LGT8F328P VS ATmega328 – 02: PINOUT [封装, 引脚]

LGT8F328P	ATmega48/88/168/328

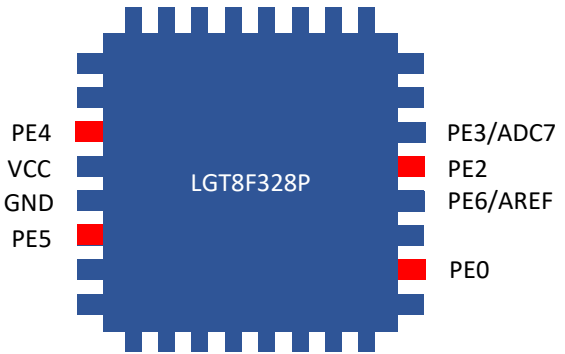
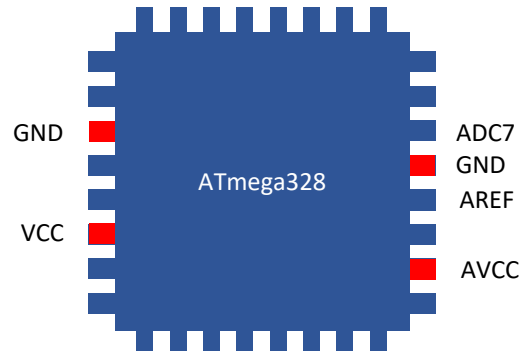
LGT8F328P-QFP32L is deeply compatible with ATmega328-QFP32L.
You can replace ATmega328 without any change of your print circuit board.
LGT8F328P is powered by PIN4/5, which is compatible with ATmega328's PIN4/5.
LGT8F328P change all other power pin to I/O pin. DO NOT USE these I/O if they are tied to GND/VCC on your board.
LGT8F328P also change ADC7/AREF to combo with GPIO function, which is not supported in ATmega328A.
